Oonoonba Urban Development Area - Stage 7 Abbott Street, Oonoonba

Rail Noise Assessment Report

PLANS AND DOCUMENTS
referred to in the PDA
DEVELOPMENT APPROVAL

Approval no: DEV2015/728

Figure 7: Recommended Acoustic Barrier

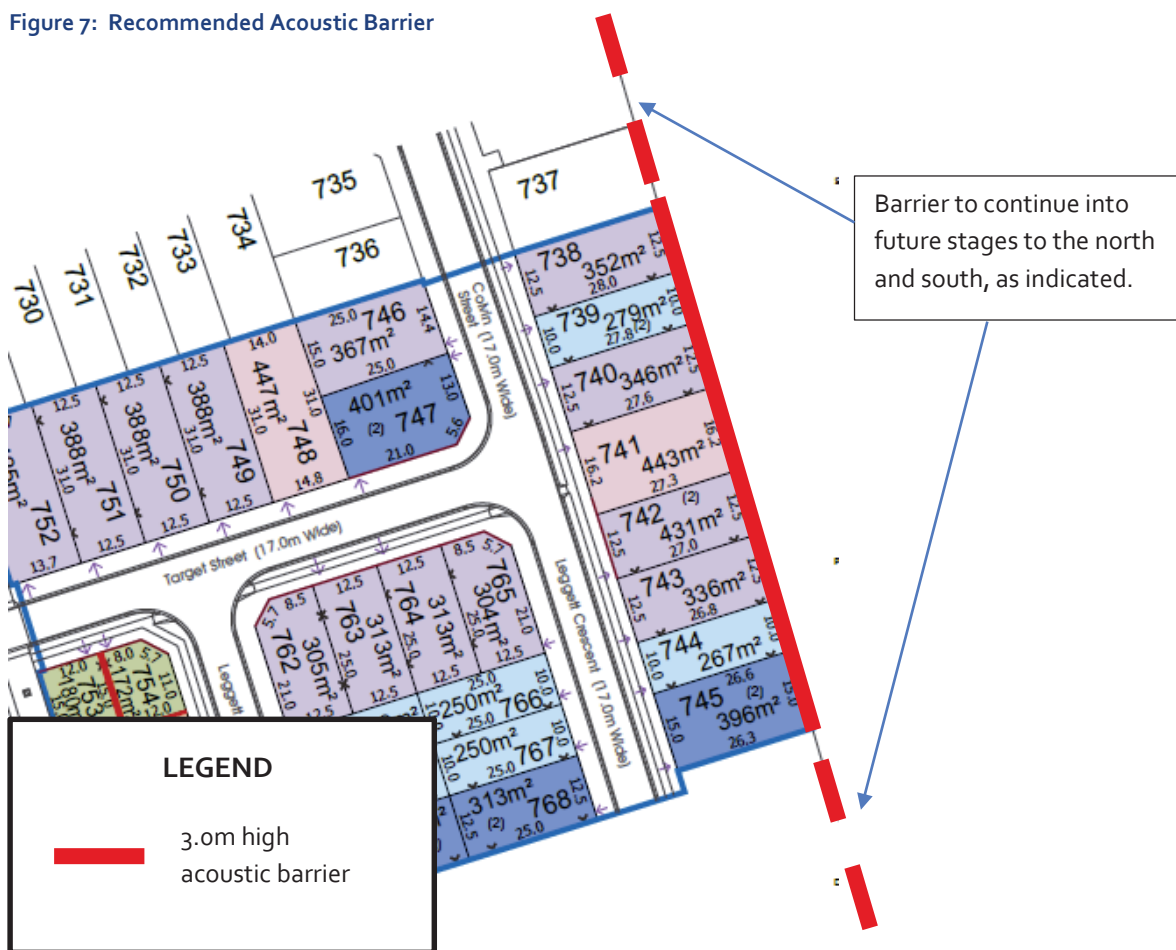
AMENDED IN RED

- The acoustic barrier should be minimum 3.0m high along the eastern site boundary. The recommendation assumes the barrier will continue along the same alignment into future stages to the north and to the south.
- The barrier height is relative to finished earthwork levels, or at a minimum RL 3.9m.
- The barrier should be constructed of a material with a surface density of at least 15kg/m² and be constructed in accordance with Queensland Rail *Civil Engineering Technical Requirement – CIVIL-SR – Design of noise barriers adjacent to railways*.
- No gaps or holes should be evident in the fence construction.
